NSA-111bdh
95V-079

**VEHICLE SAFETY DEFECT
INITIAL INFORMATION REPORT
INTERNATIONAL HORN EMBLEM
RECALL No. 151**

REF. NO. 151
INTERNATIONAL HORN EMBLEM
456 GT, 512 M, F 355 B

Position of the horn that will be 12 mm long.

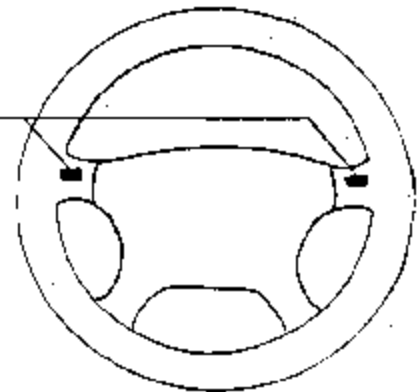
Plug in the electric tool. Wait approximately 4 minutes for the electric stamping tool to reach proper temperature.

First practice holding the stamper on the sample leather pieces (which are enclosed) for a period of 3 seconds, maintaining an even pressure. When satisfied with the testing on the sample leather pieces, place the stamper on the steering wheel in the position shown on the diagram below.

CAUTION: Any time exceeding 3 seconds will start to visibly burn the leather on the steering wheel.

Position of the horn that will be 12 mm long.

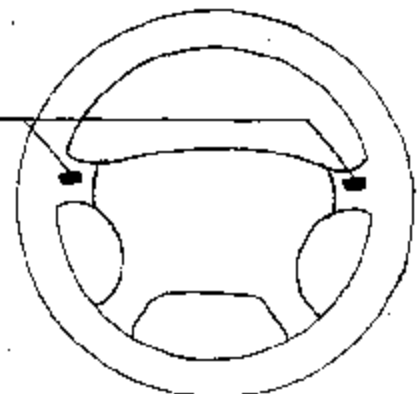
- 1) Plug the electric voltage converter into a standard 3 prong outlet.
- 2) Plug the electric stamping tool into the converter (2 prong outlet under hinged cover).
- 3) Bend the aluminum support into place and rest the tip of the stamping tool on it.
- 4) Switch on the converter.
- 5) Wait approximately 4 minutes for the electric stamping tool to reach the proper temperature.
- 6) First practice holding the stamper on the sample leather pieces (which are enclosed) for a period of 3.0 seconds, maintaining an even pressure. The correct orientation of the tool is with the flat cut towards the top.

CAUTION: ANY TIME EXCEEDING 3.0 SECONDS WILL START TO VISIBLY BURN THE LEATHER ON THE STEERING WHEEL.

- 7) When satisfied with the testing on the sample leather pieces, place the stamper on the steering wheel for a period of 3.0 seconds, maintaining an even pressure in the position shown on the diagram below, with the correct orientation.
- 8) This procedure requires 0.2 hours.
- 9) Switch off converter and allow tool to cool before storing.
